PLANNING CONSULTATION RESPONSE

Application No	2025/0153
Proposal	2025 0153 Demolition of existing dwelling (retro) and erection of 1no. detached dwelling with integral garages Hirst Cottage Billingley Updated Plans 040925
Address	Hirst Cottage Chapel Lane Billingley
Date of Consultation Reply	05.12.25
Consultee	Tony Wiles Senior Conservation Officer

GROUND FLOOR
2024/0467 vs 2025/0153

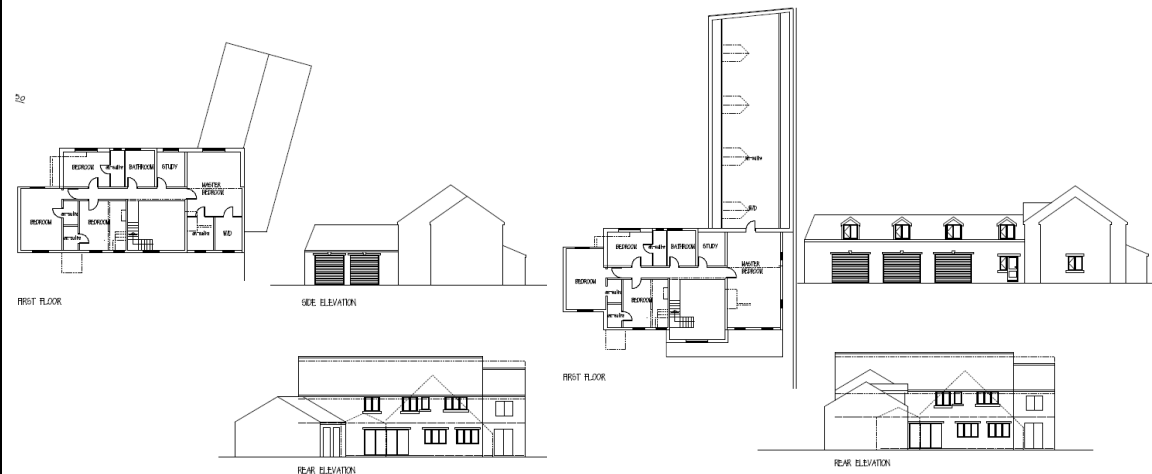
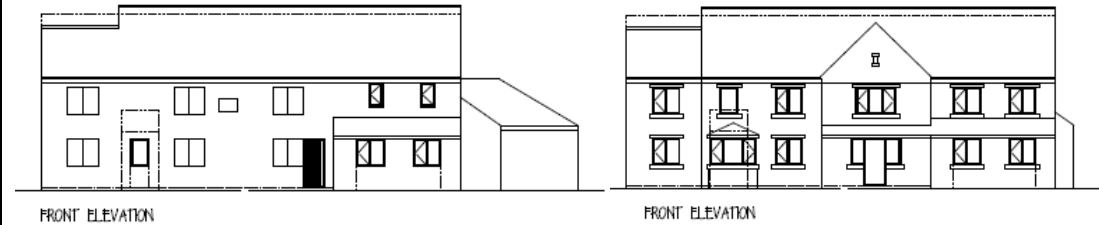
Regarding the revised plans for the new dwelling, it is generally positioned on the site in the same place. However, they appear different in scale, detail and appearance and larger than previously proposed. The following show the previously approved compared to the new plans:

In relation to the design, there is a new centrally aligned gable which was not present on the demolished building. This represents a change from the previously restrained vernacular appearance of the cottage. The overall scale of the front elevation is broadly similar to the previously approved, but the fenestration is regimented, symmetrical and more numerous. This makes the façade appear contemporary but without character. To the rear, the single storey small hipped two bay garage has grown to (effectively) four bays in width which increases the footprint. The garages are now two storeys with four gable dormers, which is a significant increase on the approved scheme. Whilst dormers can be seen elsewhere in the conservation area, these are not numerous, typical, or reflective of the vernacular. Conservation rooflights would be more sympathetic to the conservation area reducing the complexity of the roof form. The re-use of any materials from the previous building is now impossible as they have been removed from site. No comment or commitment to salvaged or re-used materials is included in this new proposal. Stone is proposed for the walls, and this would need to be natural sandstone that matches that of neighbouring buildings closely. This would need to match in terms of the coursing detail, face dressing and pointing. This could be agreed by condition following the production of a sample panel. The windows and doors are specified as brown upvc. High quality metal PPC units either in black or another heritage colour would be preferable. However, the overall design and appearance of the windows appear generic and lacking character. The inclusion of mullions in stone would improve on this as can be seen elsewhere in the conservation area. Stone heads, cills and jambs would improve on the current appearance. A condition over the detailed design including elevations at 1:20 and sections at 1:5 will be required. The roof is specified as 'tiles to match'. I would advise these should be sandstone roofing slates (good quality artificial may be acceptable) laid in diminishing courses with matching ridge tiles. A condition including samples will ultimately be required.
